Reference: Leisure Knoll at Manchester, Inc.
1 Buckingham Drive North
Manchester, New Jersey 08759
Speed Hump and exit gate
Becht Engineering BT Project No. 25-0081
Manchester Township Planning Board Application No. **PB-2025-19**
Administrative Approval
Block/Lots: 52.01/1.03
Morgan Municipal, LLC - Project No MTPB25-19

This letter has been prepared in order to provide a response to the November 25, 2025 comment letter prepared by Mr. Mathew Wilder of Morgan Municipal, LLC, the planning board engineer for the Township of Manchester. The comment letter was sent to Ms. Amanda Kisty the Manchester Township Planning Board Secretary. The comment letter was prepared in response to the Homeowners Associations application for administrative approval for the installation of five speed humps and one exit gate. Please refer to **Attachment A** found at the end of this letter for a visual representation of the five different speed hump locations and the exit gate. For convenience we have included the planning board engineer's original comments followed by our responses in ***Bold Italics***.

ATTACHMENT B

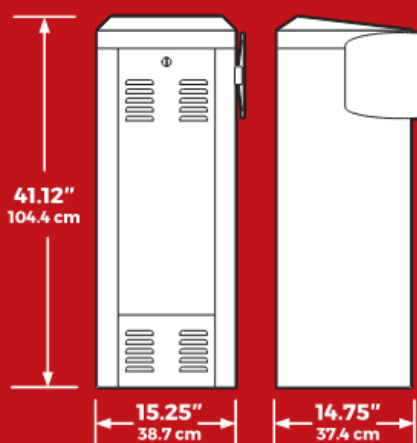
2. Applicant to provide testimony on the type of gate proposed. We recommend the gate aesthetic and functionality match the existing gate at the entrance of the Leisure Knoll development.

Please refer to Attachment B, which provides technical information for the proposed DOORKING model 1601 parking control Barrier Gate, which is aesthetic and functionally similar to the entrance gate.
